### APPEAL SUMMARY

<b>Appeal ID:</b> 27626	<b>Project Address:</b> 4800 N Lombard St
<b>Hearing Date:</b> 3/30/22	<b>Appellant Name:</b> Michael Barrett
<b>Case No.:</b> B-012	<b>Appellant Phone:</b> 541-968-9374
<b>Appeal Type:</b> Building	<b>Plans Examiner/Inspector:</b> Connie Jones
<b>Project Type:</b> commercial	<b>Stories:</b> 1 <b>Occupancy:</b> B, M <b>Construction Type:</b> V-B
<b>Building/Business Name:</b> University Park	<b>Fire Sprinklers:</b> No
<b>Appeal Involves:</b> Alteration of an existing structure, Reconsideration of appeal	<b>LUR or Permit Application No.:</b> 21-039721-CO
<b>Plan Submitted Option:</b> pdf [File 1] [File 2] [File 3] [File 4] [File 5] <b>Proposed use:</b> Retail

### APPEAL INFORMATION SHEET

## UNPROTECTED OPENINGS @ SUITE 4800

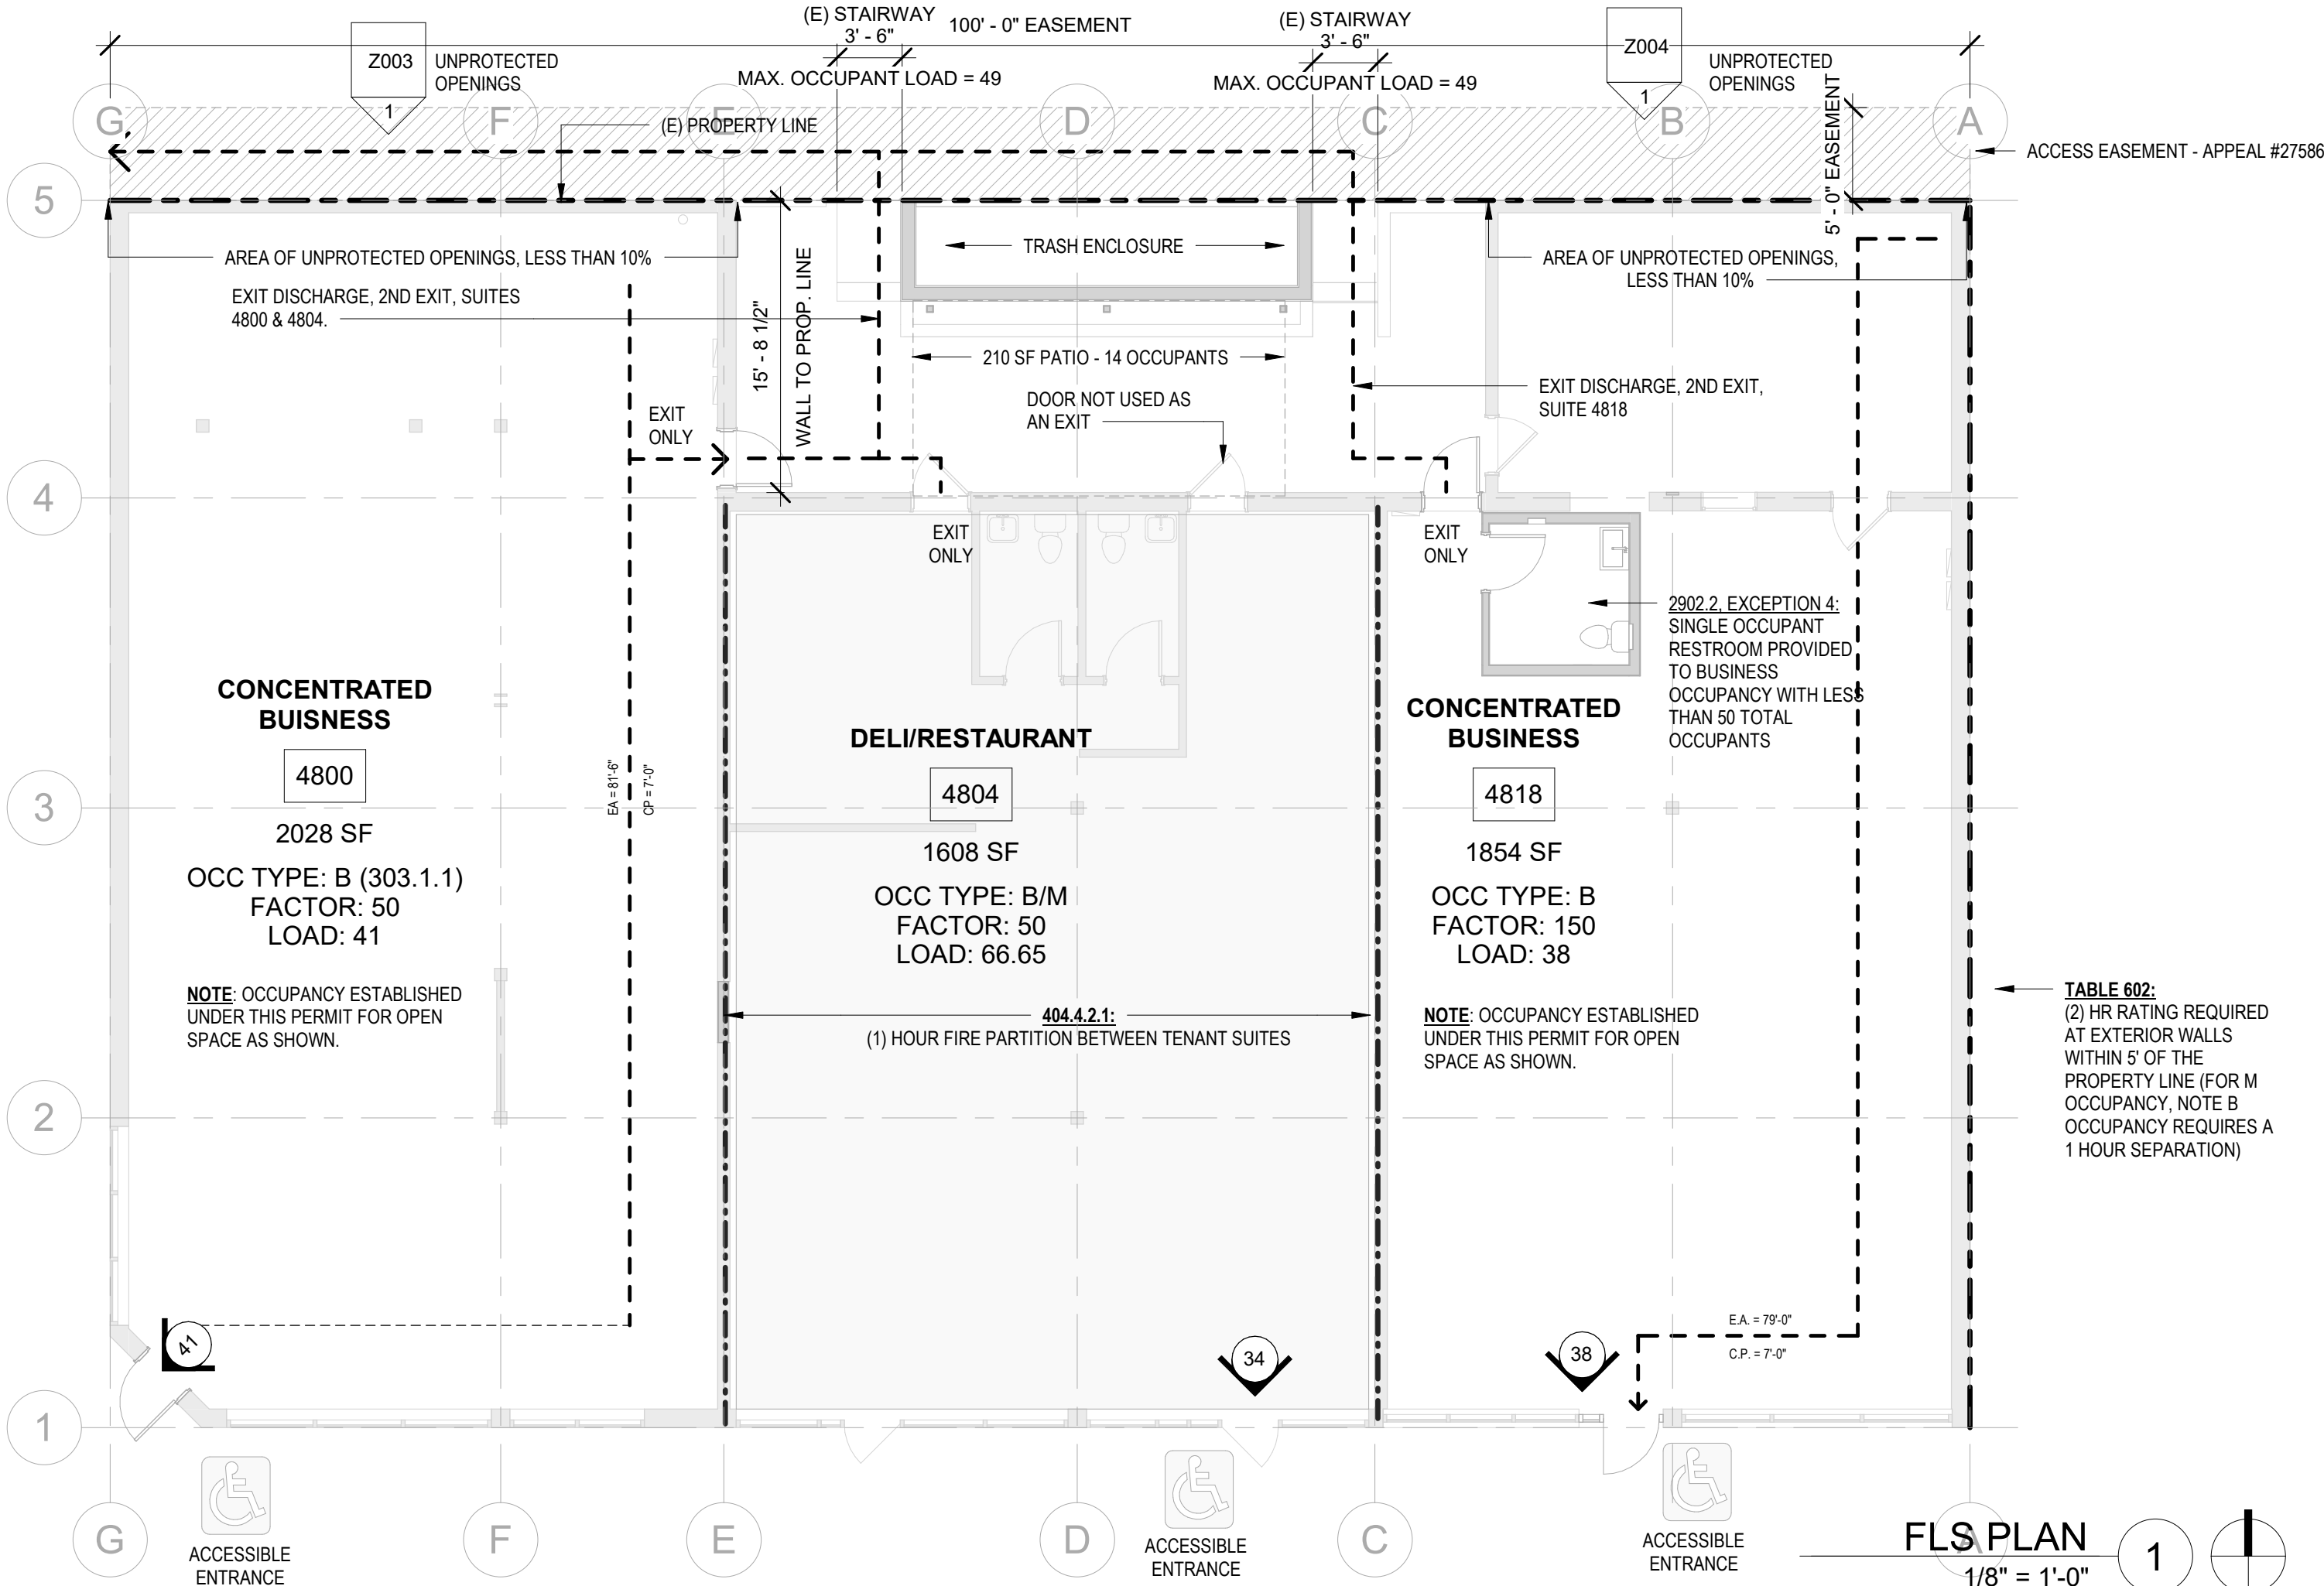
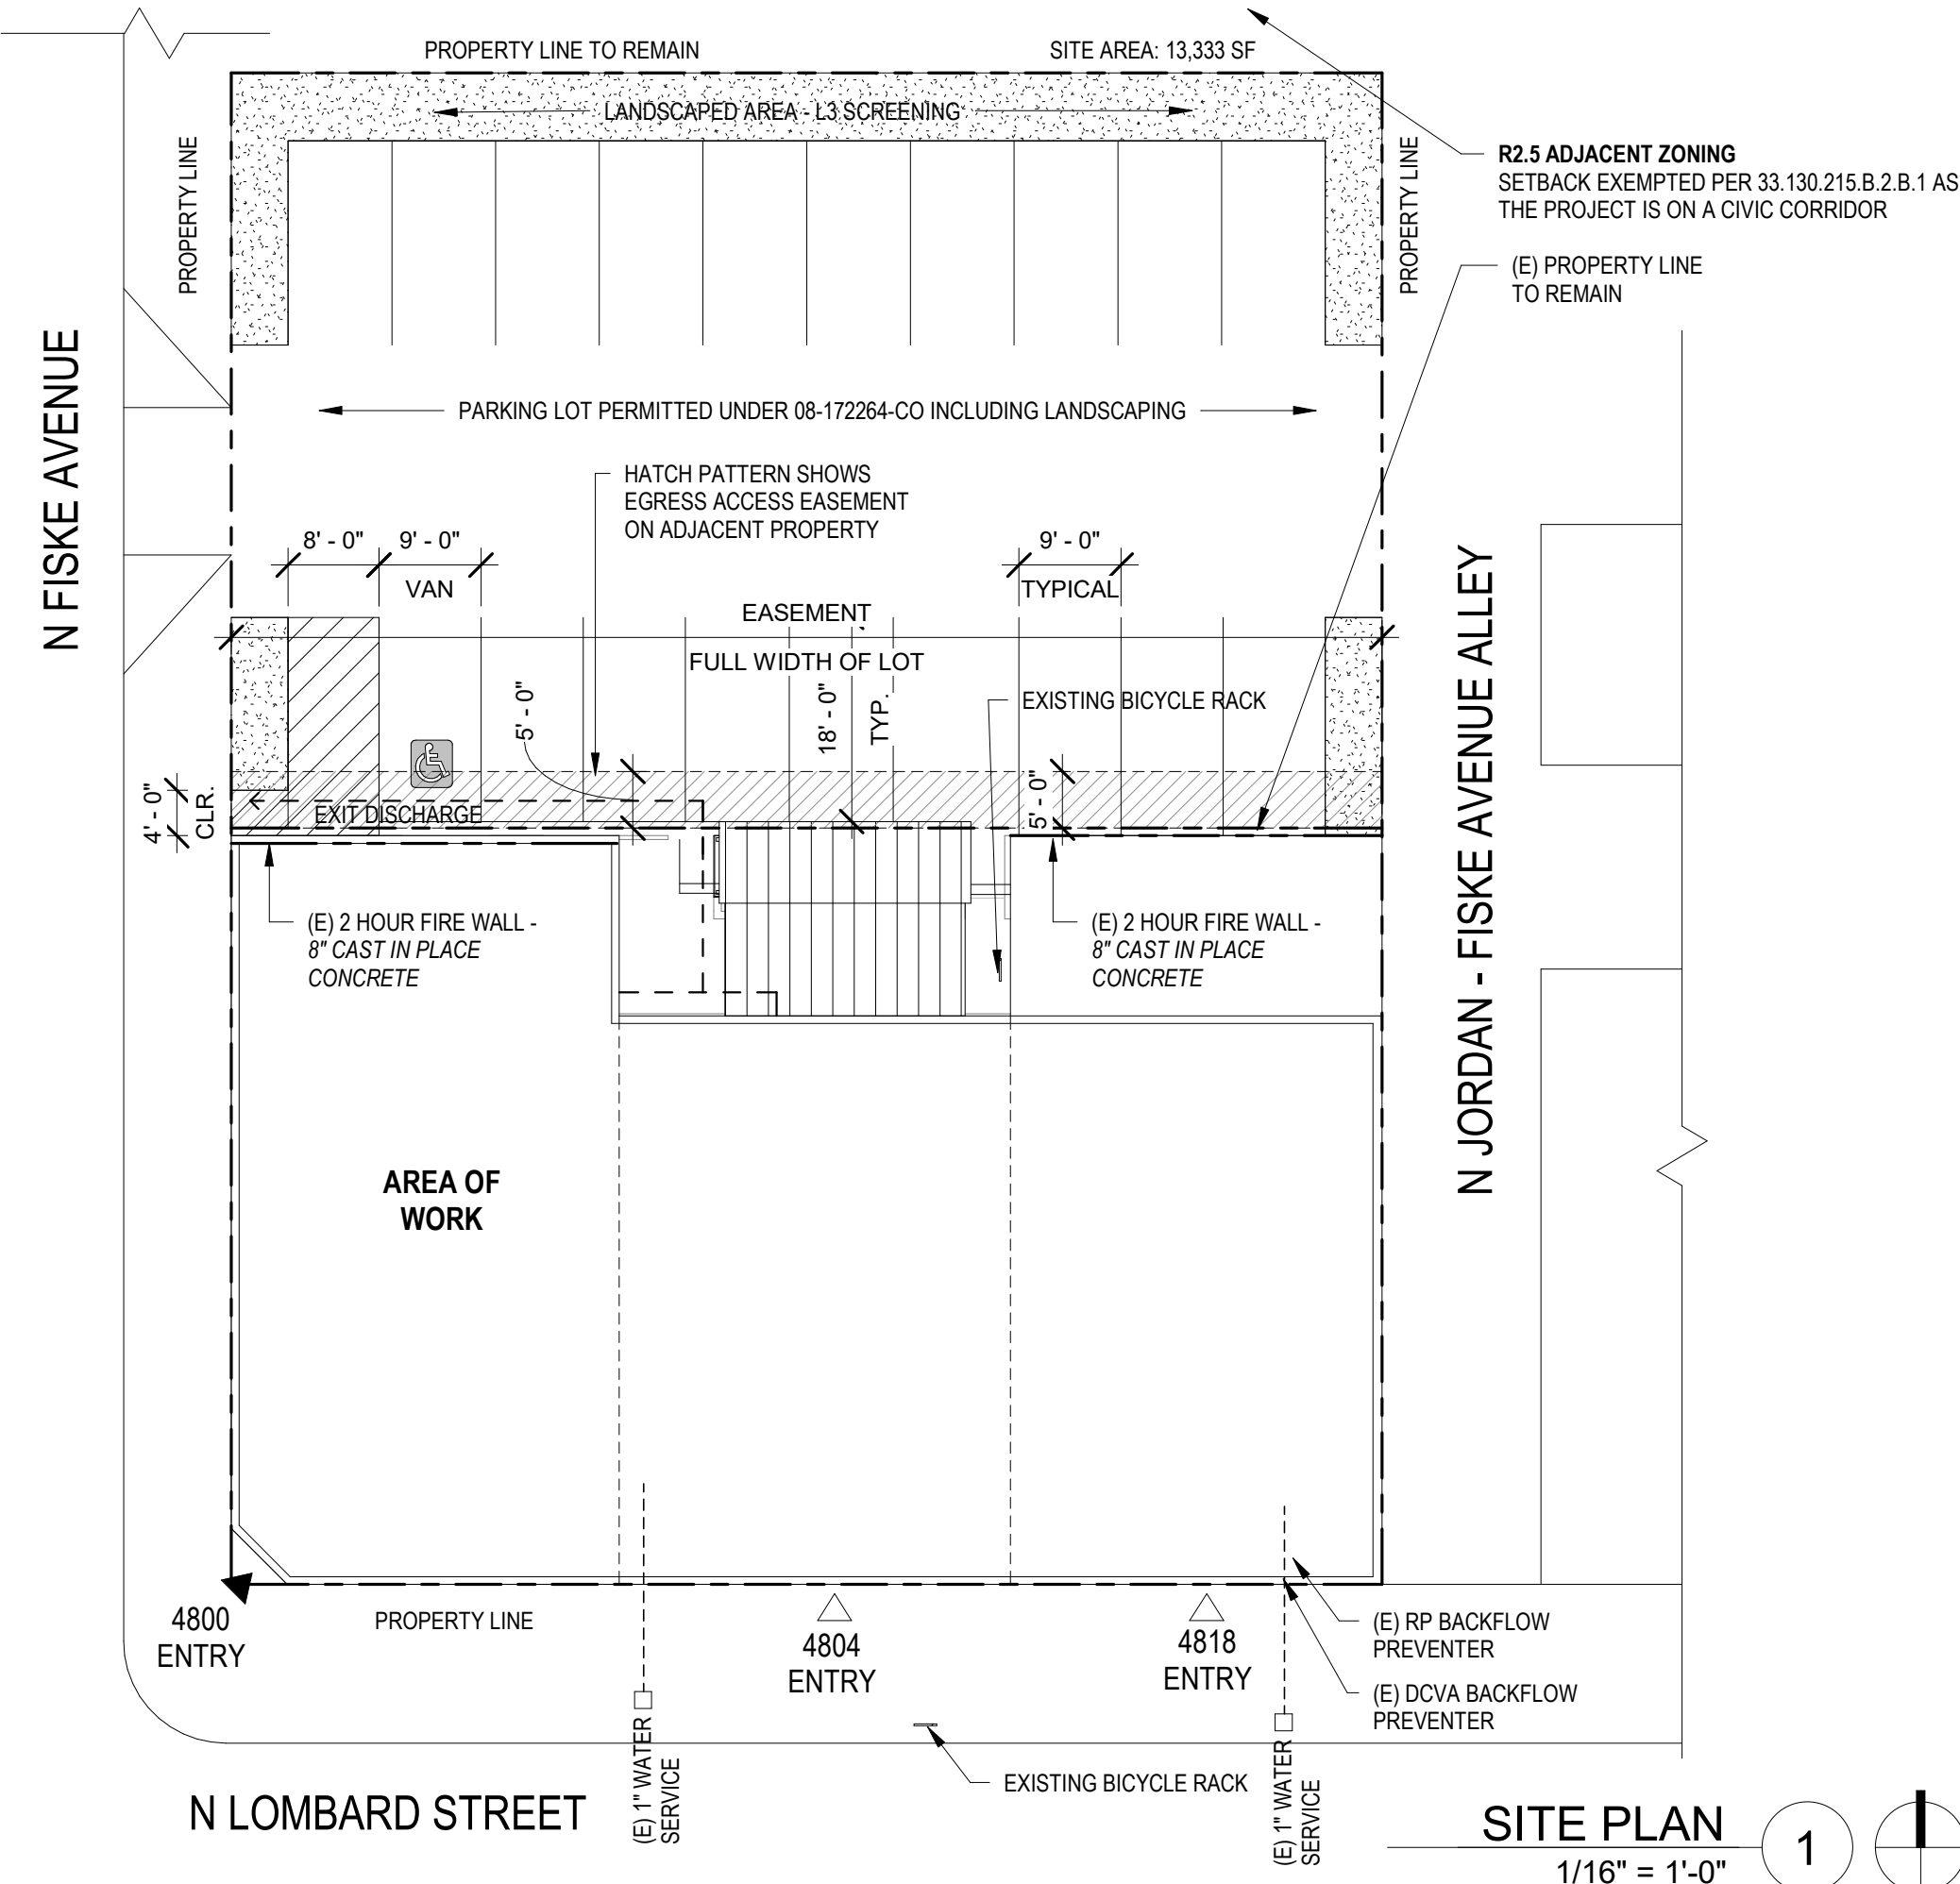
Unprotected openings to be less than 10% of the total wall area in conformance with OSSC Table 705.8 for exterior walls 5 feet away and are non-sprinklered. Elevations calculation the existing openings as a percentage of the exterior wall area are provided as Exhibits Z003 & Z004 along with supporting photographs of these walls.

This appeal proposes to use the existing openings only and does not propose new openings. This equates to approximately 4.6% of the wall within Suite 4800 and 3.1% of the wall within Suite 4818.

Two existing openings exists along the property line within existing two hour cast in place concrete walls with a 2 hour rating. Rather than record a "do not sell separately" agreement, the project team seeks to record a permanent 5' setback through an easement agreement recorded with the county.

**1. Increase in allowable area of unprotected exterior wall openings with 100 foot x 5 foot no build easement along the adjacent South property line of the lot to the North: Granted provided a recorded No Build Easement is provided prior to plan review approval.**

**Appellant must contact Nancy Thorington (503-865-6438) for more information prior to writing the no build easement and the no build easement must be reviewed and approved by BDS prior to recording. The easement must include language that establishes the edge of the easements on the adjacent lot as the implied property line for the purpose of determining fire separation distance for future development on the adjacent lot.**
